Subject: Response to U.S. EPR Design Certification Application RAI No. 547 (6499, 6359), FSAR Ch. 3 - NEW PHASE 4 RAI, Supplement 6 - Part 1 of 4
Sent Date: 4/29/2013 5:18:22 PM
Received Date: 4/29/2013 5:20:57 PM
From: WILLIFORD Dennis (AREVA)

QUESTIONS for Structural Engineering Branch 2 (ESBWR/ABWR Projects) (SEB2)

Question 03.07.02-78**Open Item****Follow-up to RAI 371, Question 03.07.02-66 and RAI 376 Question 03.08.05-28.**

Figure 3.7.2-78-8: Wall 2 - Soil 1n2ue & 1n5aeh (Cracked Concrete Case)

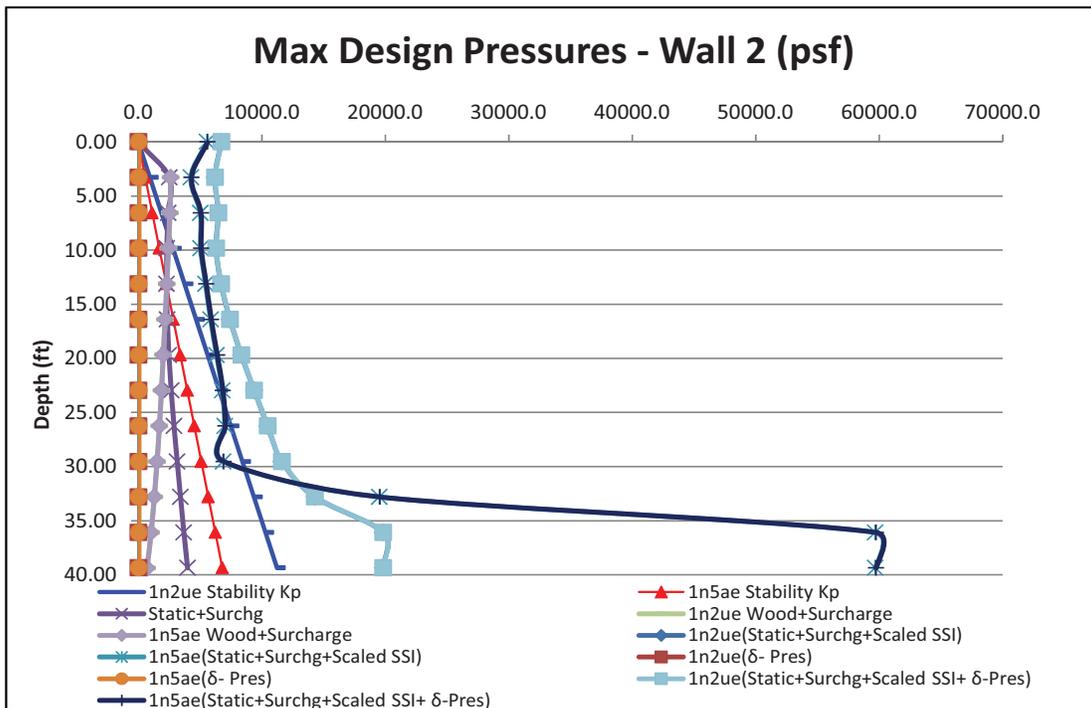
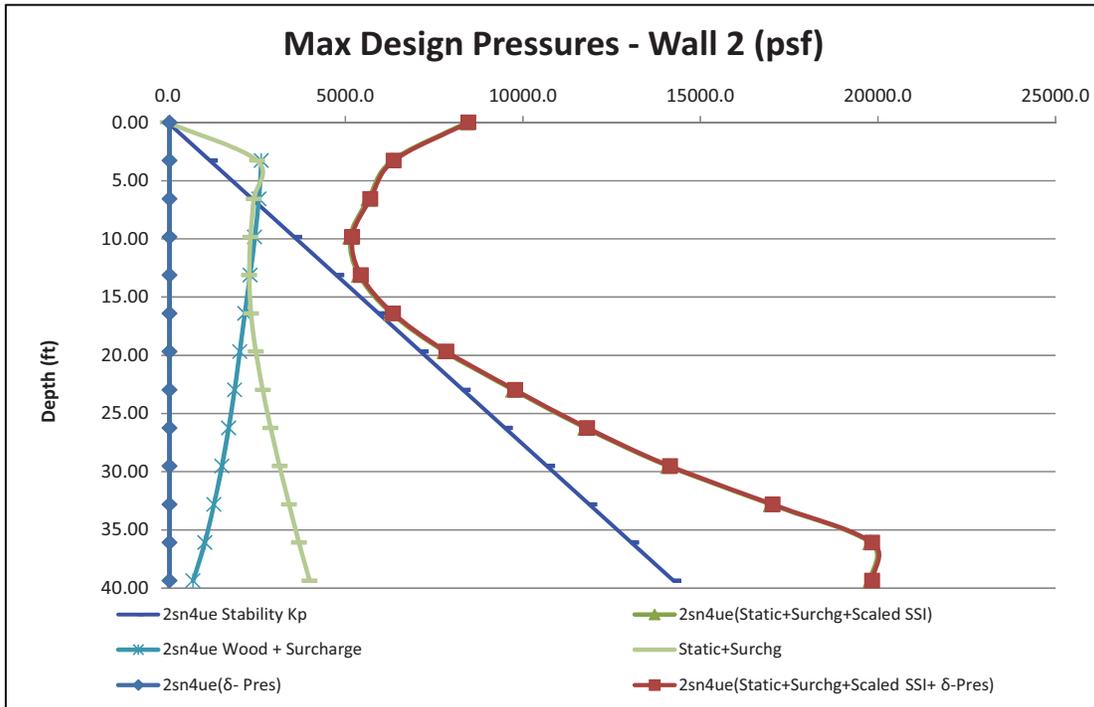
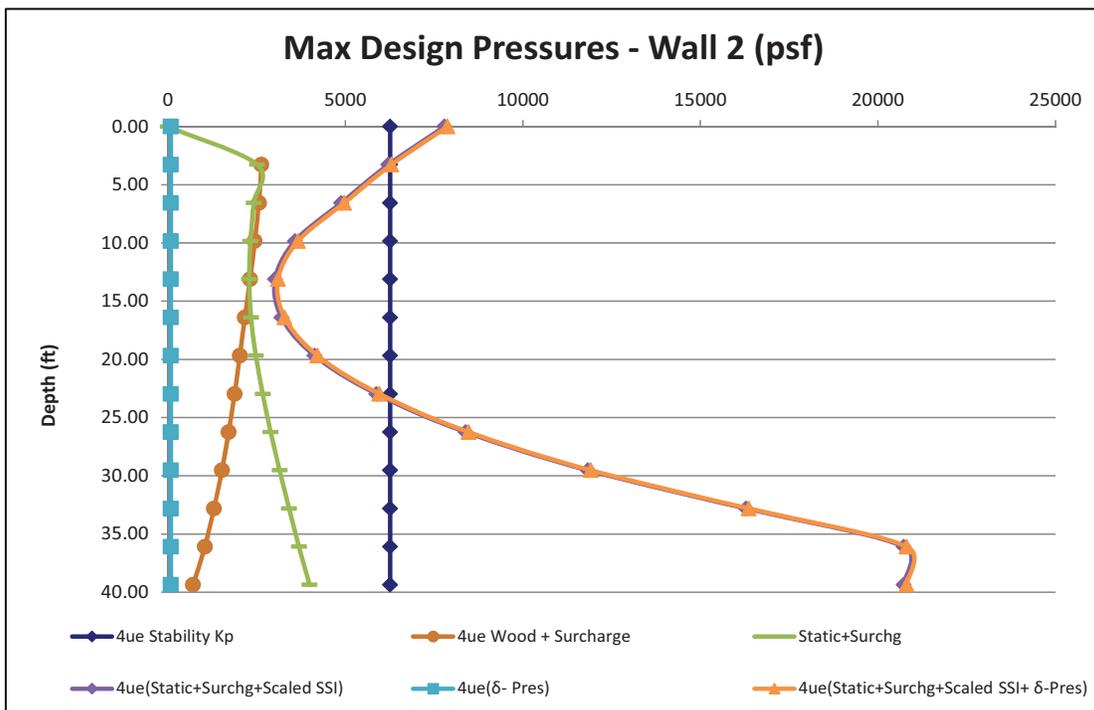
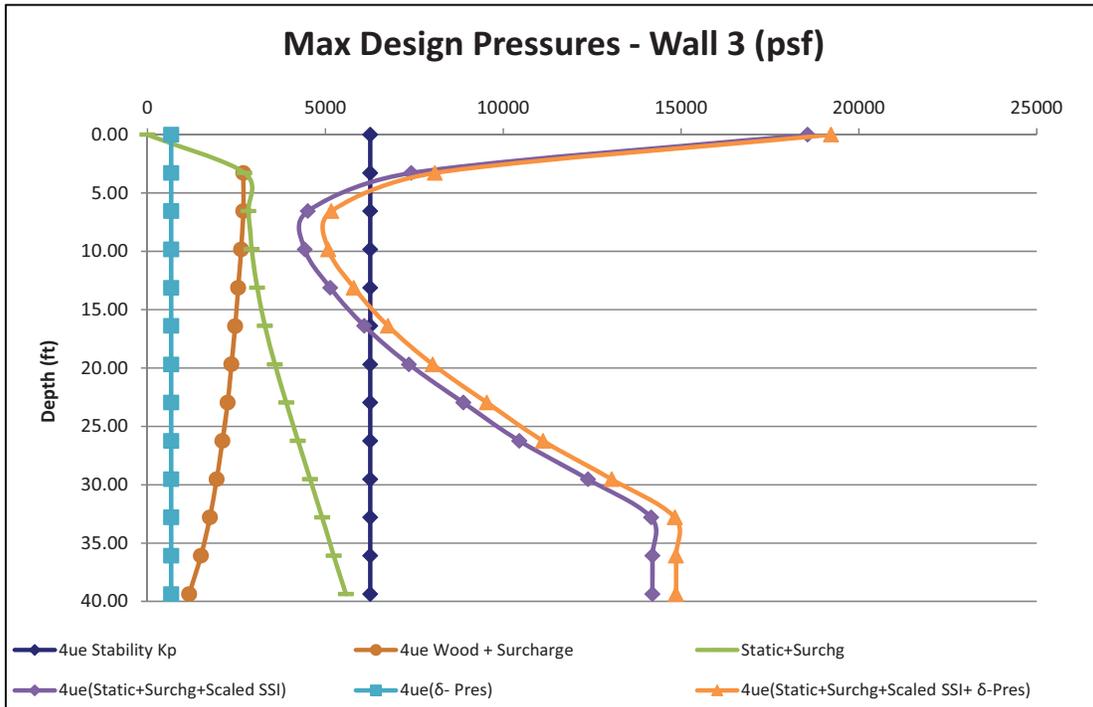
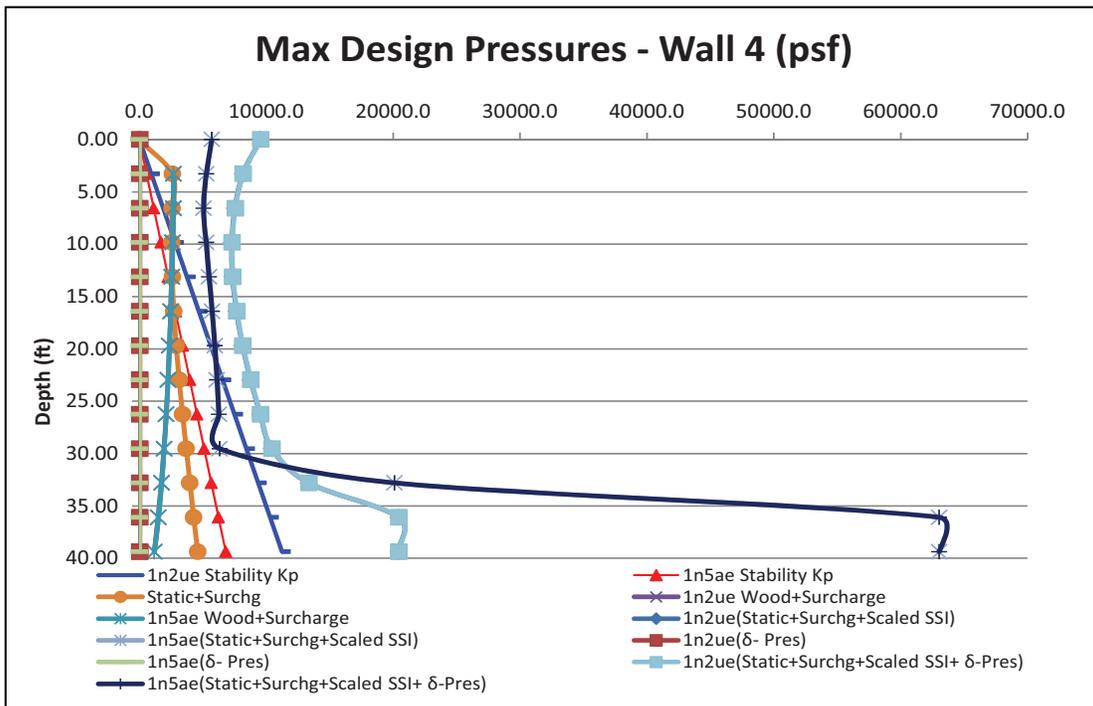
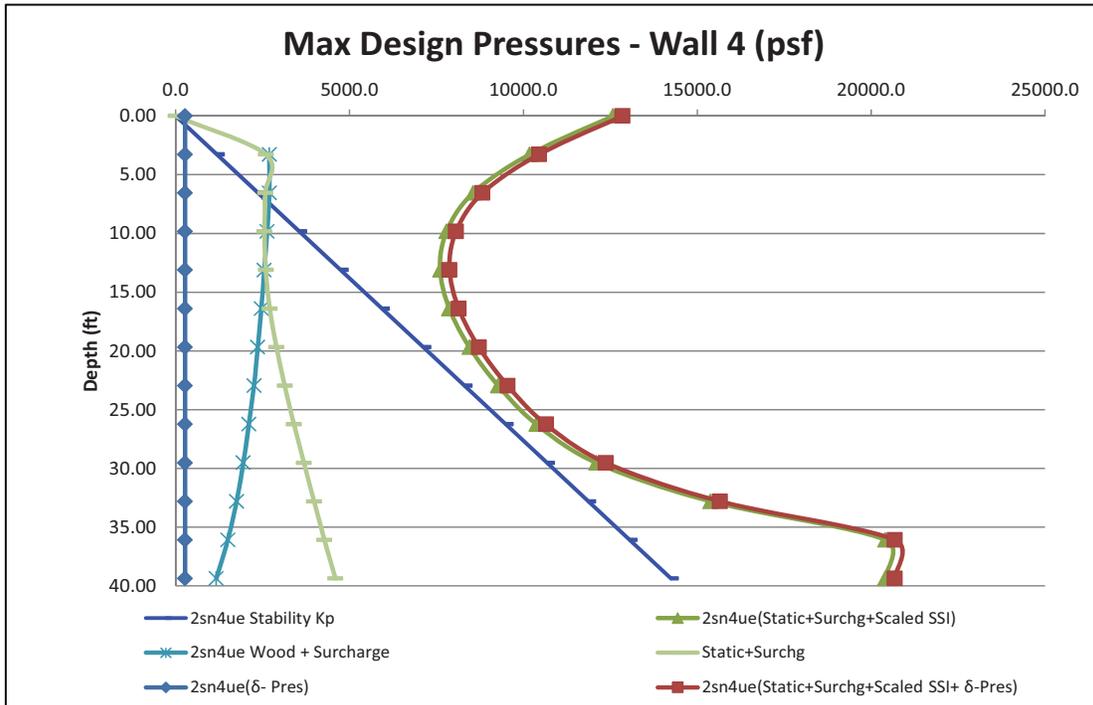
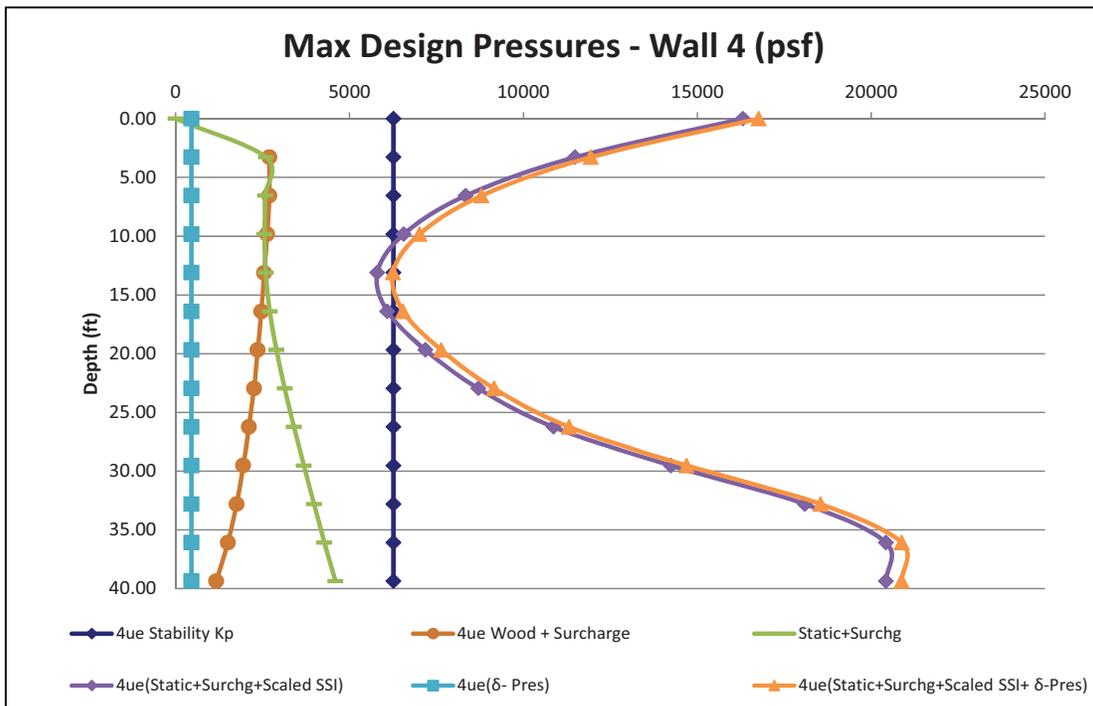
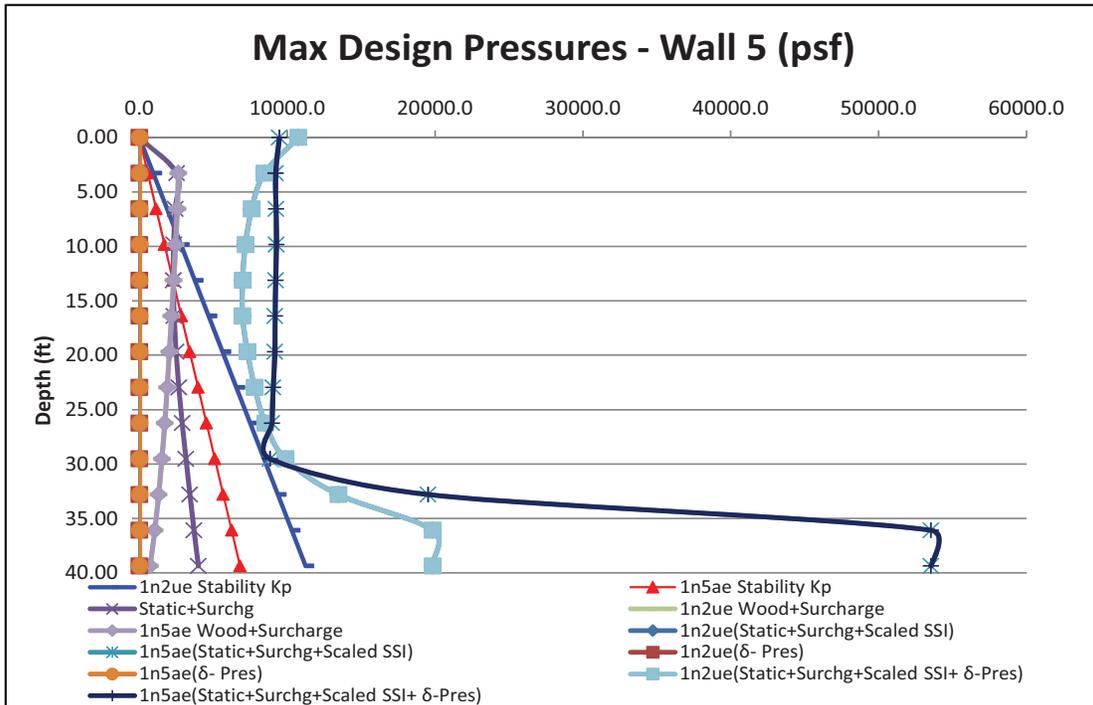
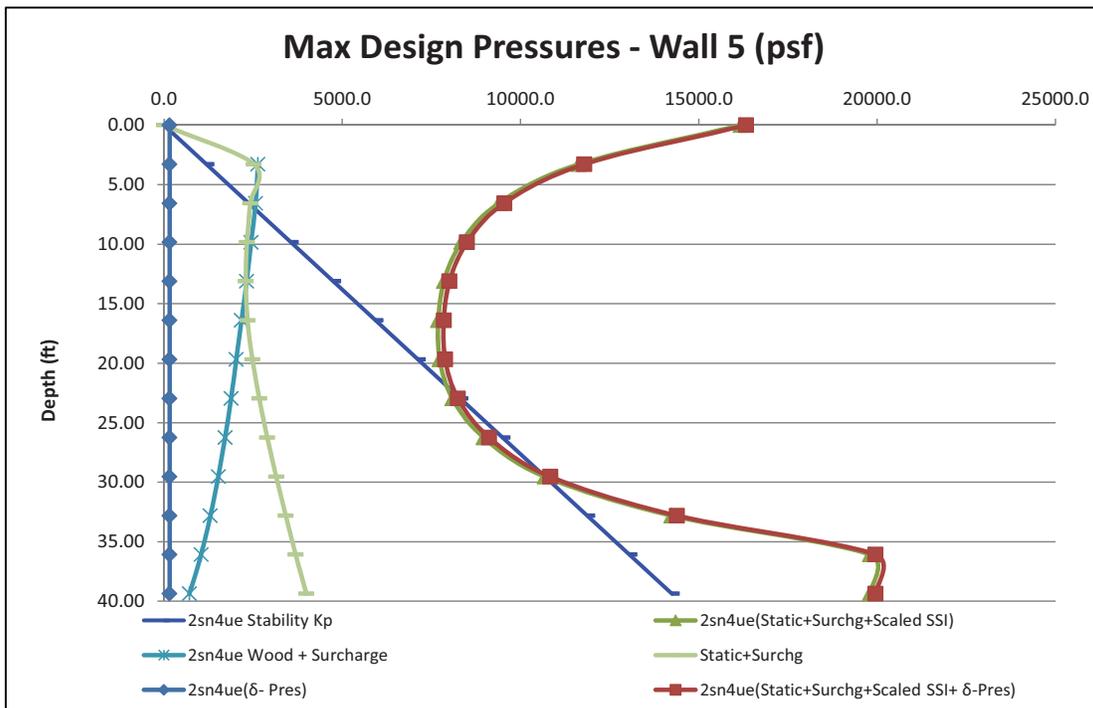
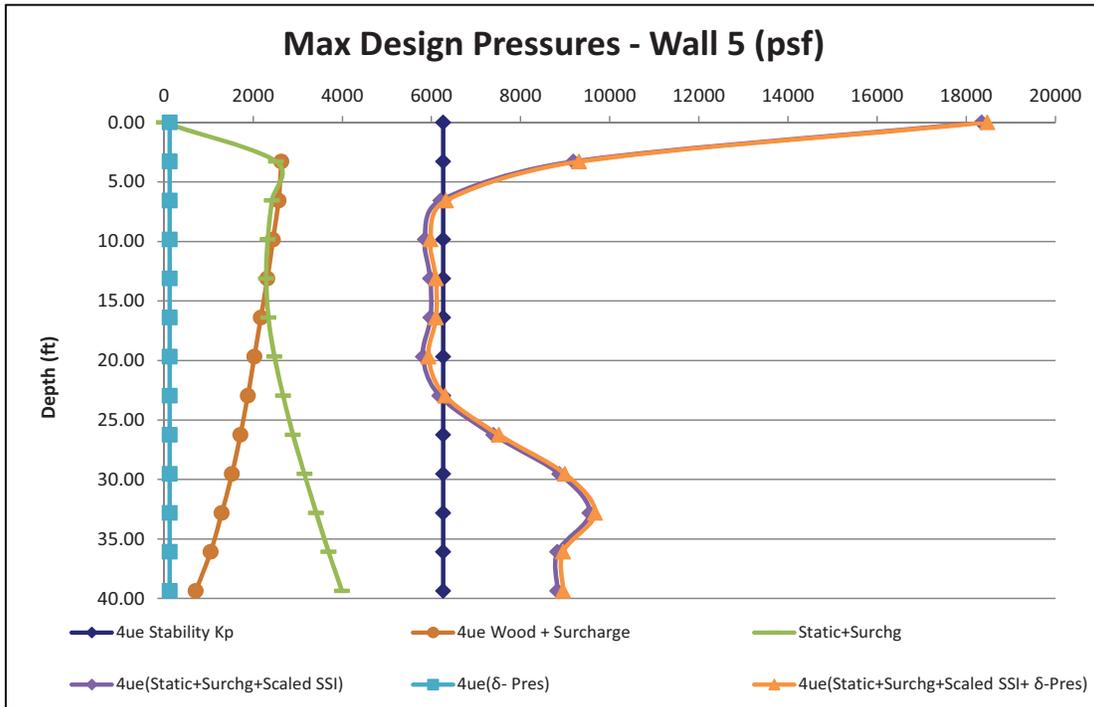
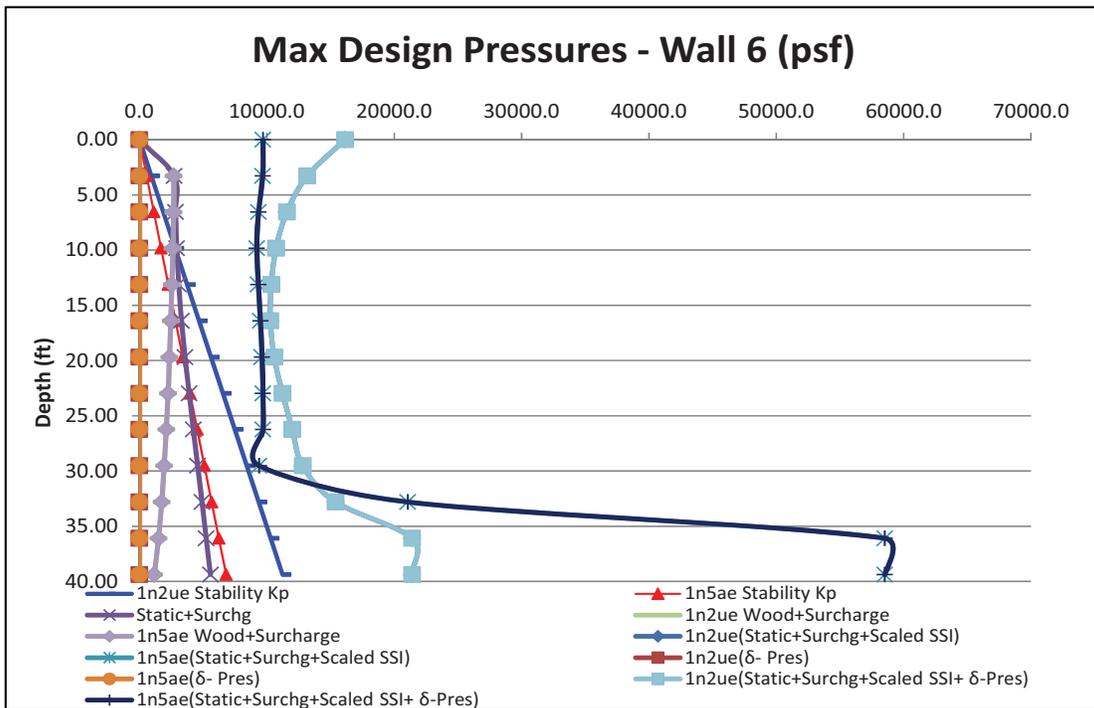
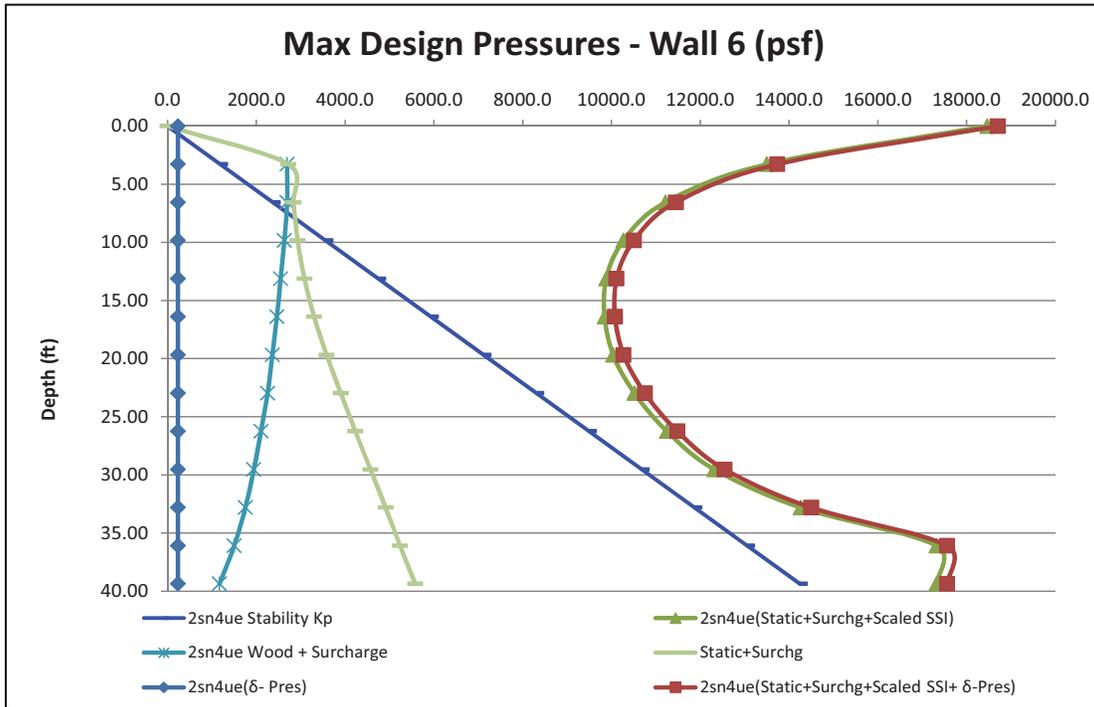
- (a) To ensure that the referenced figures in RAI 376 Question 03.08.05-28 provide a consistent comparison, confirm that all the pressure profiles shown represent the combined effect of static plus surcharge plus seismic loads, including the profiles identified as Wood's solution. How are the static and surcharge loads combined with the scaled SSI pressures and to the passive pressures from the stability analysis?

- (c) A review of the referenced figures indicates that, for a given wall, soil, and analysis case, it does not appear to be always true that the scaled SSI pressure profile always bounds the pressures required by the sliding stability analysis. For example, in Figure 03.08.05-28-5 (Wall 2, "cracked" analysis) the vertical "4uem Stability K_p " profile (blue line) is greater than the "4uem" profile (magenta line) at depths between approx. 5 ft. and 25 ft. A similar situation is observed in Figure 03.08.05-28-61 (Wall 2, "uncracked" analysis). This is due to the difference in the relative shape of the two pressure profiles. Since the applicant indicates that it is not using an envelope of all soil cases (such as the ones shown in Figures 03.08.05-28-42 through 03.08.05-28-59 and Figures 03.08.05-28-98 through 03.08.05-28-115), but is considering each soil case independently, explain how

- (d) It appears that the additional pressures due to the localized sliding/uplift of the basemat (i.e., the “delta pressures” described in the response to RAI 371 Question 03.07.02-66, listed in Tables 03.07.02-66-1 and 03.07.02-66-2) were not included in the referenced figures in RAI 376 Question 03.08.05-28. It therefore does not provide the staff with an accurate representation of the total soil pressures acting on the walls, which was the intent of the original RAI. Therefore, the applicant should provide a revised version of the figures in RAI 376 Question 03.08.05-28 that includes the SSI pressures, the delta pressures, and the combination of the two for all embedded walls including the tendon gallery. The information provided should be consistent with the information requested under Question (1) of this RAI.

- (c) The combined static, surcharge, delta pressure, and scaled SSI pressures generally bound the pressures required by the sliding stability analysis (SSI analysis). The example cited in the Response to RAI 376, Question 03.08.05-28, corresponds to the soil case 4uem for which a uniform soil pressure of 43.5 psi for the walls and 50 psi for the TG was applied to provide the minimum factor of safety for sliding. Note that for soil case 4uem, the scaled SSI pressure with static, surcharge and delta pressures do not bound the stability pressure case at certain local sections of the wall (between roughly 5 ft. and 25 ft. from the top). However, Figure 3.7.2-78-46 through Figure 3.7.2-78-55 show that other soil cases would govern the design of the walls; and, in fact, exceed the stability pressure requirements of soil case 4uem. In soil case 2sn4uem for walls 5 and 11, only minor sections of the wall were not bounded by the scaled pressures. However, the design of the wall would be governed by the larger sidewall pressures at the top and bottom of the walls where the scaled SSI pressures are significantly greater than the stability pressures.

- (d) Figure 3.7.2-78-8 through Figure 3.7.2-78-37 show the stability (K_p); static and surcharge; Wood's and surcharge; static, surcharge, scaled SSI and additional (delta) pressure due to localized sliding/uplift of the basemat; and the combined delta pressure, scaled SSI, static and surcharge for the embedded walls.
